Subject: Duke Energy Carolinas, LLC (Duke Energy)  
William States Lee III Nuclear Station - Docket Nos. 52-018 and 52-019  
AP1000 Combined License Application for the  
William States Lee III Nuclear Station Units 1 and 2  
Responses to Request for Additional Information  
Ltr# WLG2011.07-04

**Lee Nuclear Station Response to Request for Additional Information (RAI)**

**Lee Nuclear Station Response to Request for Additional Information (RAI)**

Figure 1. 2480 MW Combined Cycle Plant Water Usage Impact on Water Surface Elevations of Make Up Ponds with Refill from the Broad River (85-year record) and Future Water Demands

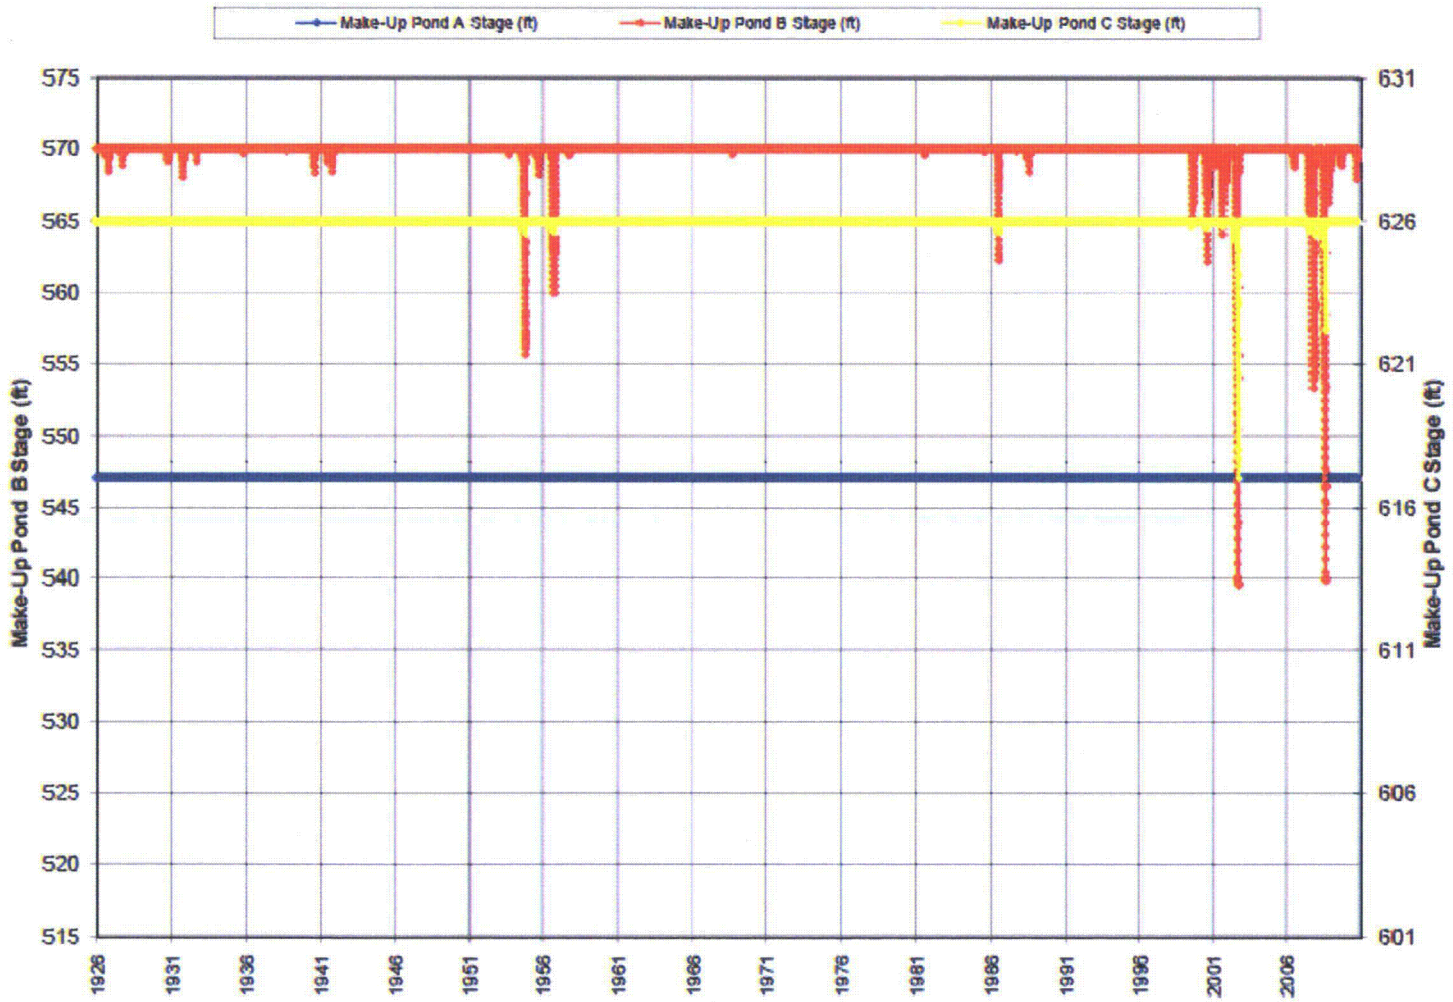
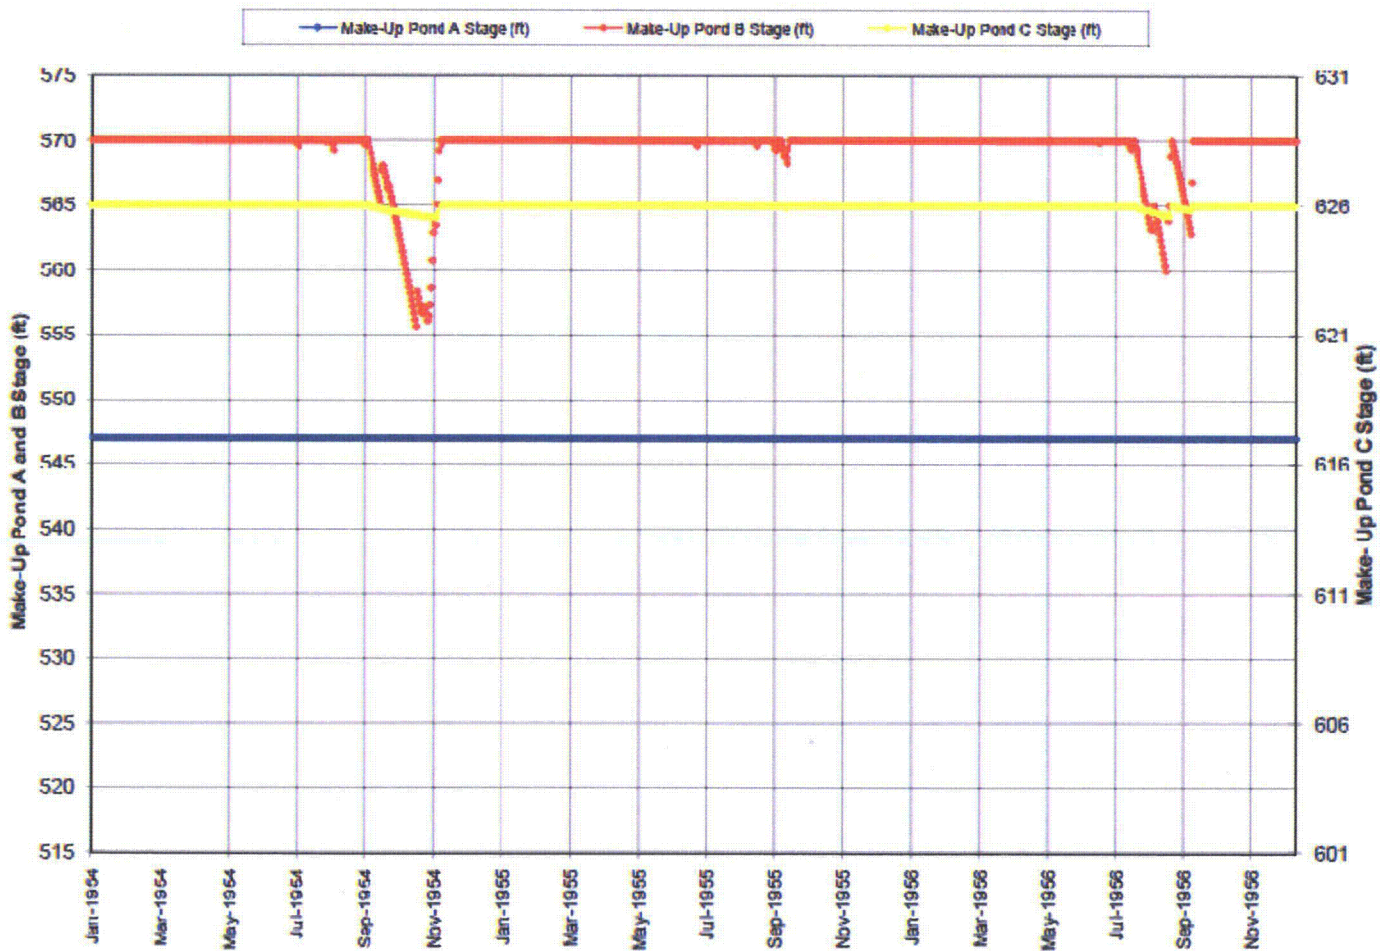
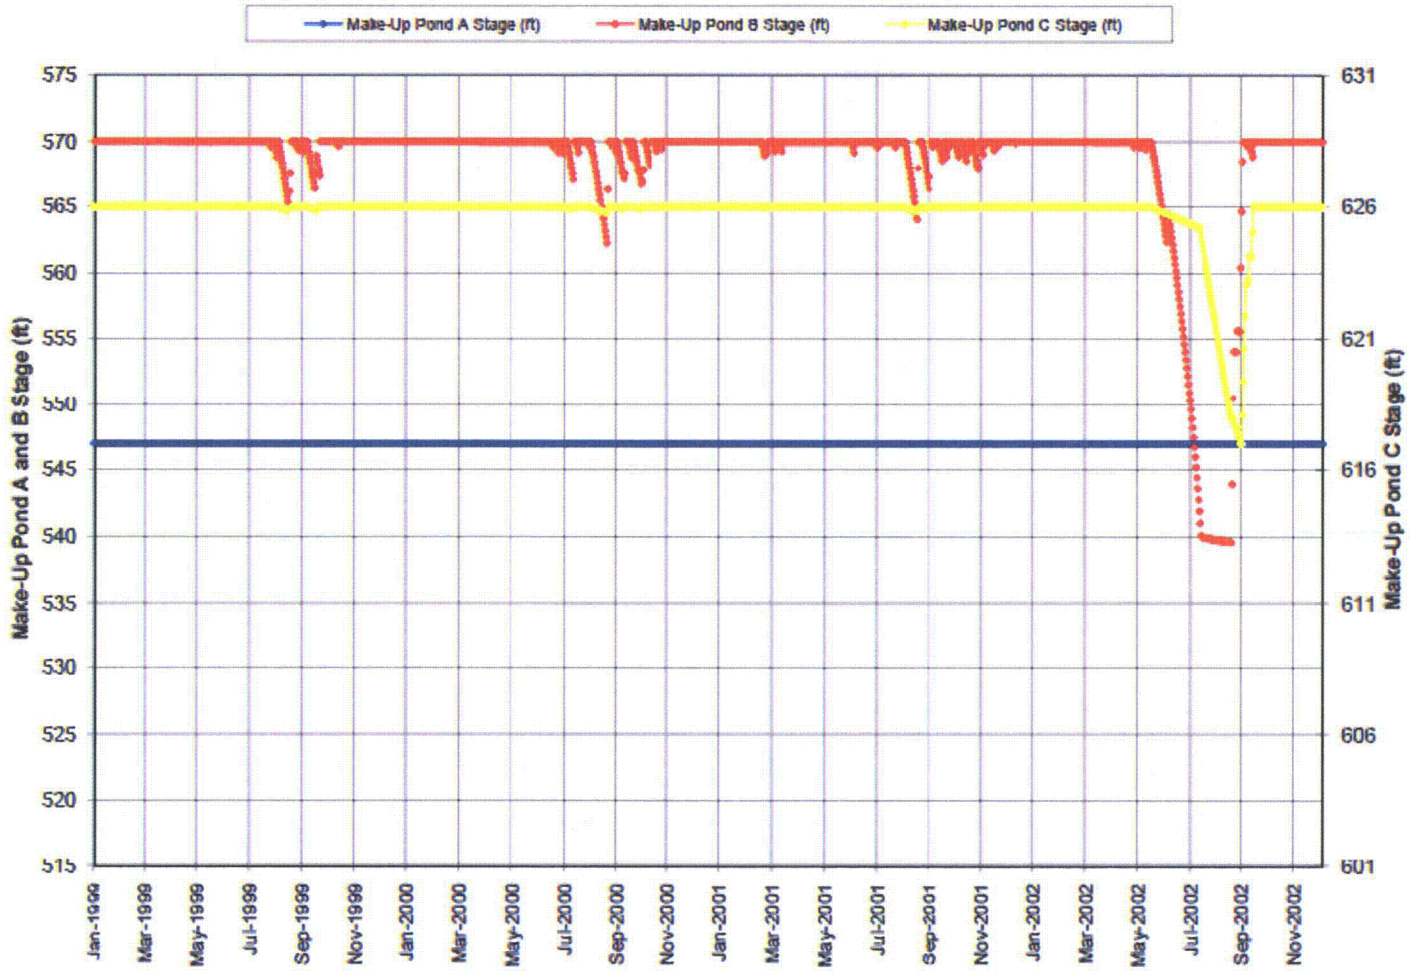
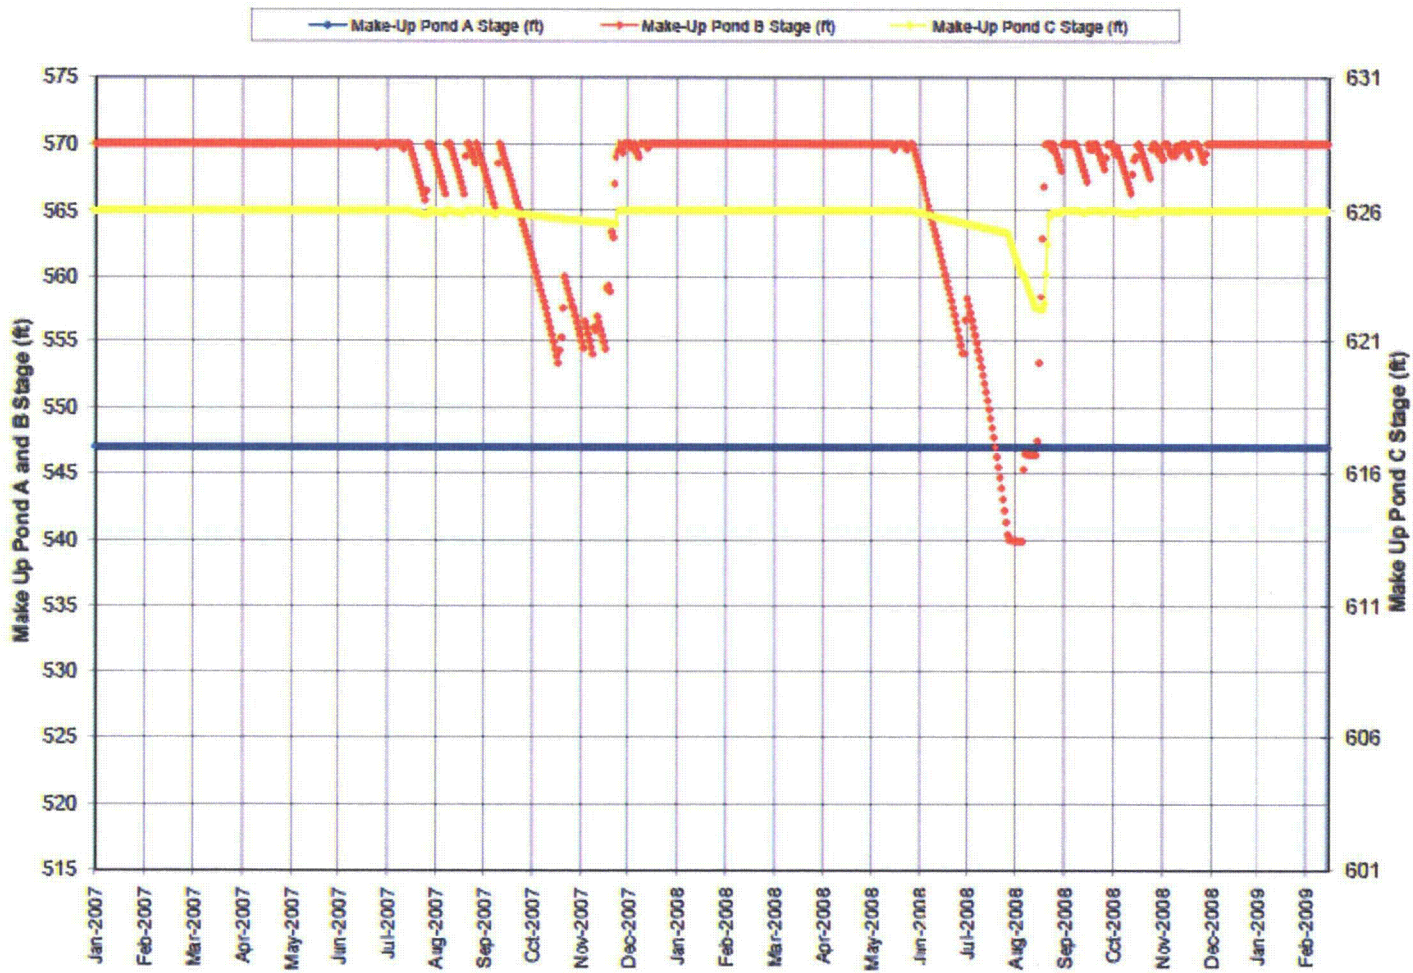
- Present the water balance model/results for the most recent 10 year period of flow data for the Broad River (2001 through 2010)
- Present the water balance model/results based on the hypothetical condition that the seasonal flow release limits in the Federal Energy Regulatory Commission (FERC) license for the Ninety-Nine Islands Dam would apply as constraints on Lee Nuclear Station withdrawals (bounding evaluation)
- Provide land use and ecology impacts for supplemental water options of (a) building a smaller Make-Up Pond C and (b) expanding Make-Up Pond B to support operation of a four unit natural gas combined cycle station at the Lee Nuclear Station site.

to this letter). Histograms showing drawdowns of Make-Up Pond B and Make-Up Pond C for this scenario, originally provided in Duke Energy's response to ER RAI 123 (Reference 3) have been revised and are provided as Attachments 123S-02 through 123S-05.

Figure 6. Make-Up Pond B Excavation

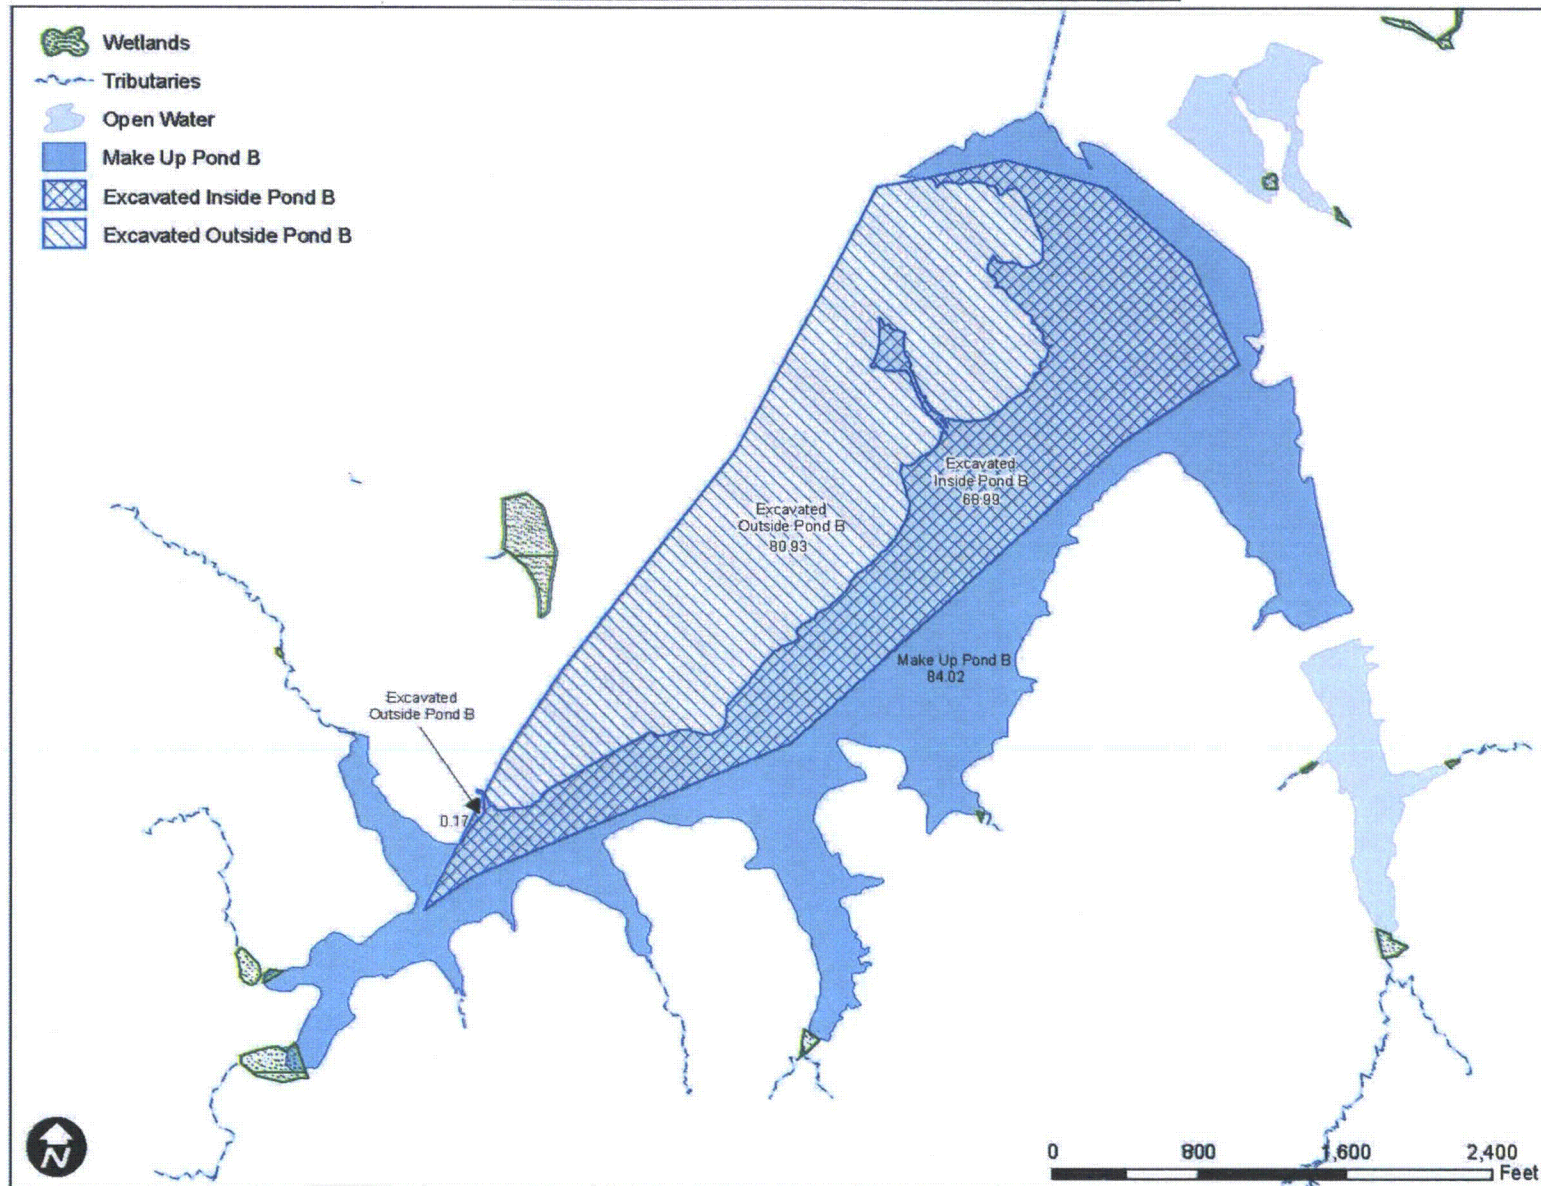
At the June 2 and 3, 2011 NRC audit, the NRC Staff requested that Duke Energy evaluate enlarging Make-Up Pond B to provide supplemental cooling water for a Natural Gas Combined Cycle generation alternative. Duke Energy's response to ER RAI 128 (Reference 4) concluded that expanding Make-Up Pond B to provide supplemental cooling water for a hybrid (wet-dry) cooling alternative was not an environmentally superior alternative. Water balance model results based on Natural Gas Combined Cycle and 5% Mean Annual Flow of 125 cfs relative to expansion of Make-Up Pond B are summarized below. Note that these results reflect only the additional volume of supplemental water required to support station operations through significant droughts beyond the usable storage volume of 3,156 ac-ft of storage used from existing Make-Up Pond B.

Expanding existing Make-Up Pond B to provide supplemental make-up water during times of drought for the Lee Nuclear Station was evaluated in the ER Supplement and Duke Energy's response to ER RAI 128 (Reference 4). Raising the height of the Make-Up Pond B dam and excavating the entire pond were evaluated to provide the supplemental storage volume. These evaluations identified flood protection concerns with raising the Make-Up Pond B dam to increase storage. Upon further evaluation, Duke Energy determined that it would not be possible to obtain the volume of storage required for the natural gas combined cycle plant while maintaining 3:1 slopes within the existing pond footprint. Therefore, Duke Energy evaluated an option to excavate the land adjacent to the northern and western shore of the pond to obtain the required storage volume. With this approach, the northern portion of Make-Up Pond B and the adjacent uplands would be excavated to 510 ft msl while maintaining 3:1 slopes. To accomplish this expansion, Make-Up Pond B would be completely drained and excavators used to obtain the required depth. Approximately 69 ac of Make-Up Pond B and 81 ac of additional area would be excavated as shown in Attachment 123S-08. Approximately 11 million cubic yards of unconsolidated material would be excavated.

If Make-Up Pond B were excavated to provide supplemental make-up water, the pond would be completely dewatered. Existing fish and other aquatic communities would be eliminated during the excavation. Removal of the surface water would substantially reduce hydrology of wetlands adjacent to Make-Up Pond B and would lead to temporary impacts. Excavation into the uplands would impact forested and non-forested communities. Impacts to vegetation due to the Make-Up Pond B excavation are provided in Attachment 123S-06.

**Figure 7. Possible Spoil Locations at Make-Up Pond C Site**

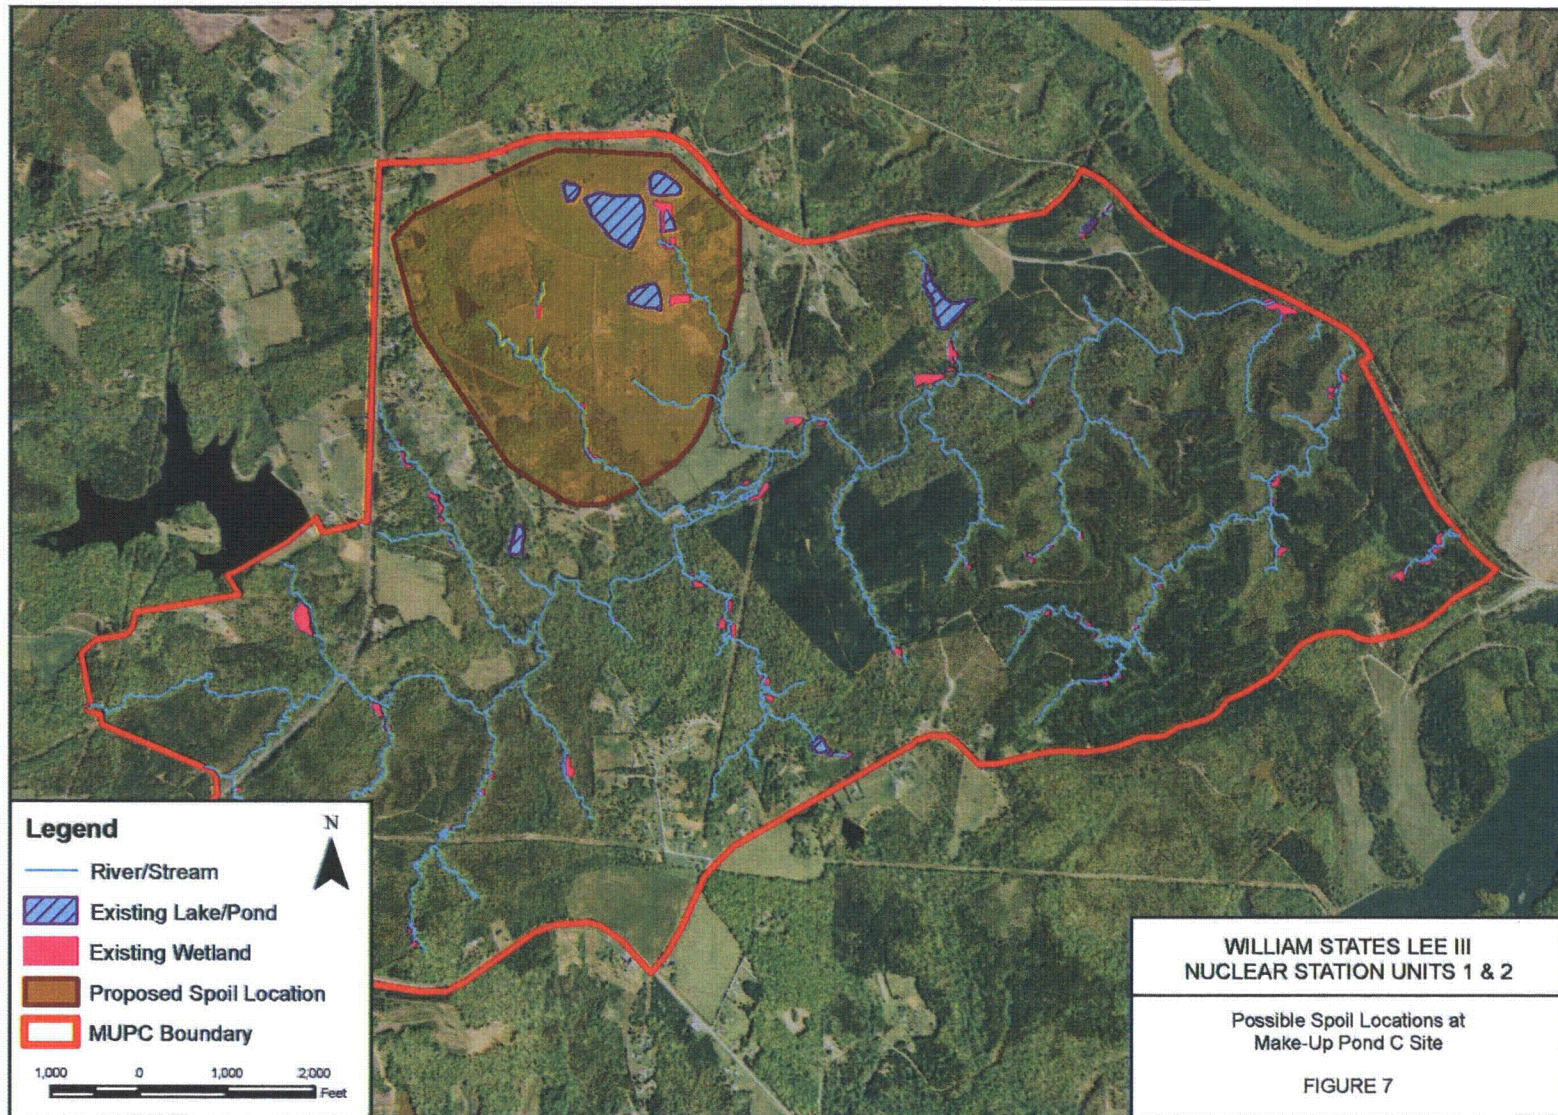
Since the presentation of the spoil areas during the June 2 and 3, 2011 NRC audit, Duke Energy conducted further evaluation on the size and location of the spoil piles to account for existing site topography. Duke Energy first evaluated locating the spoil material only in uplands on the Make-Up Pond C site; however, steep onsite topography limits the use of many upland areas when considering the requirement for a minimum of 3:1 slopes. Therefore, the old agricultural fields and more disturbed streams north of London Creek (relative to those south of London Creek) were considered for stockpiling as shown in Attachment 123S-09. Additional space for laydown areas or other work space may be required in addition to the permanent spoil pile area, but have not been included for this conceptual layout. Erosion and sediment control best

In order to place the excavated material at the Make-Up Pond C site, a temporary haul road would need to be constructed from the Make-Up Pond B area and then cross London Creek via a temporary road crossing. A portion of the existing Rolling Mill Road could be upgraded to minimize impacts. A haul road has not been designed for this alternative. In areas where excavated material would be placed, vegetation would be cleared and topsoil would be removed to serve as cover for the spoil material. Excavated material would be placed primarily within uplands, but would also need to be placed within open water areas, streams, and wetlands due to site topography. Impacts to vegetation, wetlands, streams, and open water are summarized in Attachment 123S-06. The significant altering of the site topography and removal of forested areas would have observable effects within the watershed such as increased runoff and altered catchment areas. This could lead to changes in hydrology of the onsite streams, including London Creek. Additional incising and stream instability would likely occur.
